Ref: 0818r02v01

**RE: 154 – 158 PACIFIC PARADE, DEE WHY (DA 2025 / 0024)
DEVELOPMENT APPLICATION FOR DEMOLITION WORKS AND CONSTRUCTION OF SHOP TOP HOUSING
INCLUDING STRATA SUBDIVISION
LETTER OF RESPONSE TO COUNCIL**

TRAFFIC & PARKING COMMENTS WITHIN THE COUNCIL RFI LETTER

Attachment 4

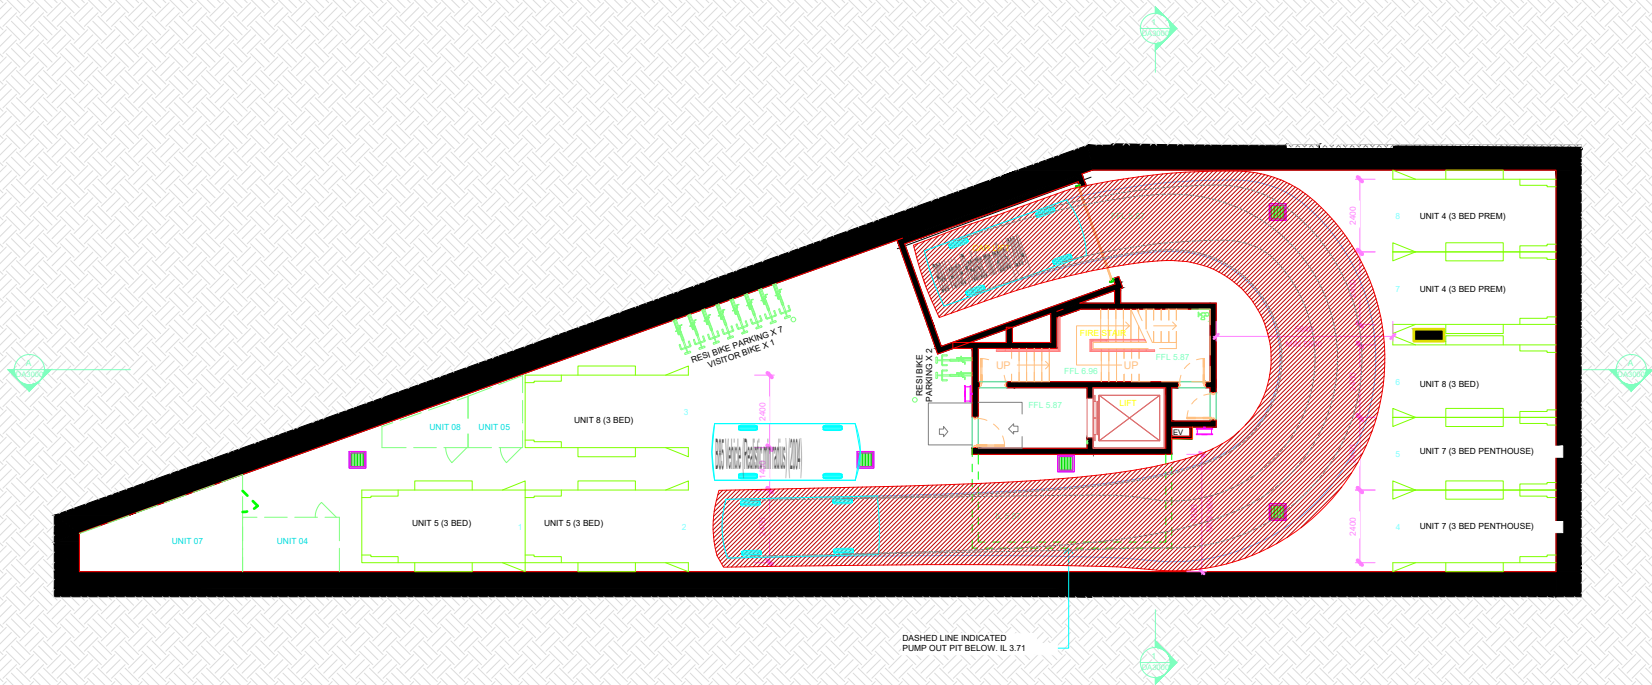
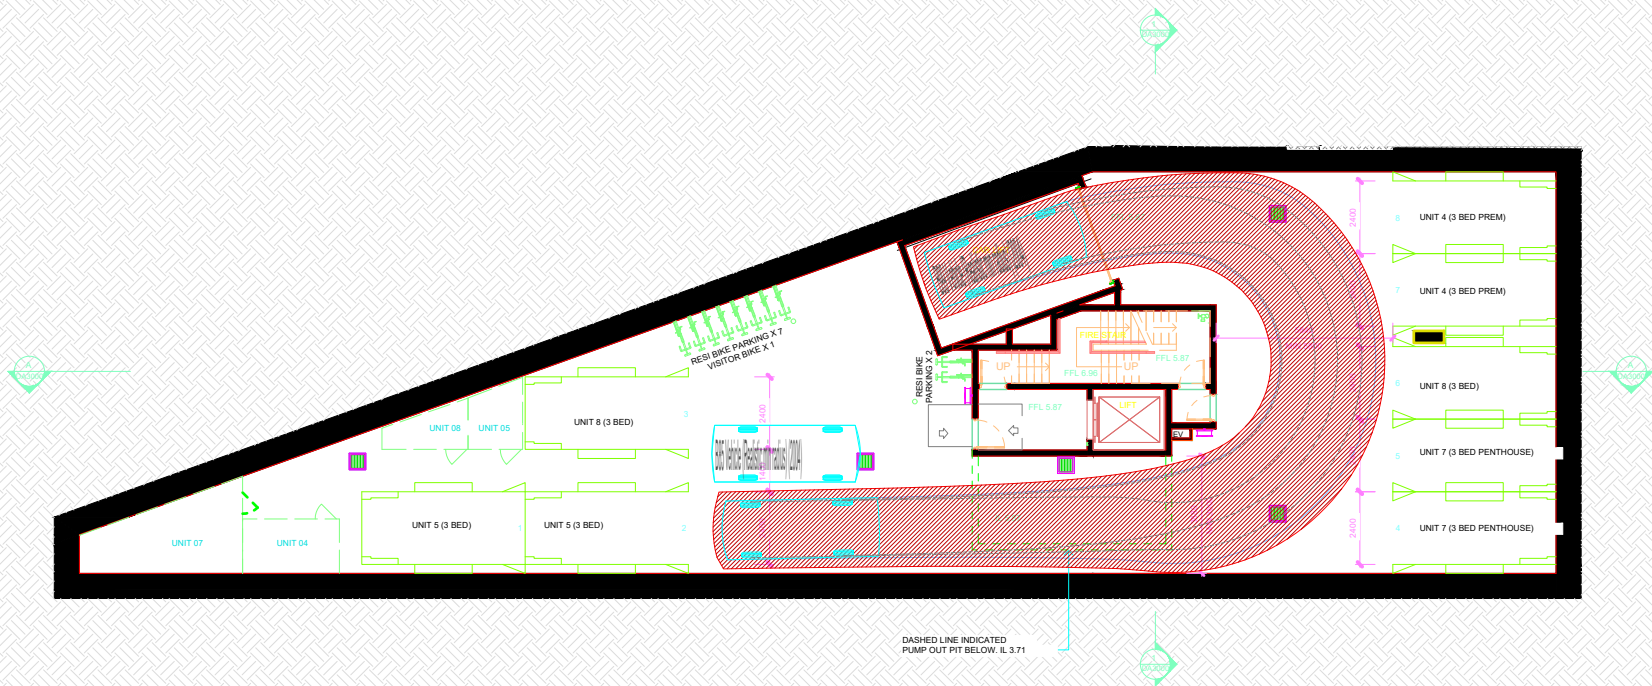
- The width of the vehicle access, at the property boundary, has been widened by 0.3 metres to the north, to ensure there is sufficient clearance between a waiting inbound vehicle and adjacent kerb. Revised swept path analysis has been undertaken with the results included as **Attachment 4** confirming satisfactory entry and exit movements and vehicle passing.
- The visual splay triangle on the egress side of the driveway, at the property boundary, does not provide the entire unobstructed clearance noting a slender column will be located within it. And so, filtered sightlines will be provided that an exiting driver and pedestrian would still see each other along the footpath. Nevertheless, to improve sightlines at the access, a convex mirror as shown in the architectural drawings.
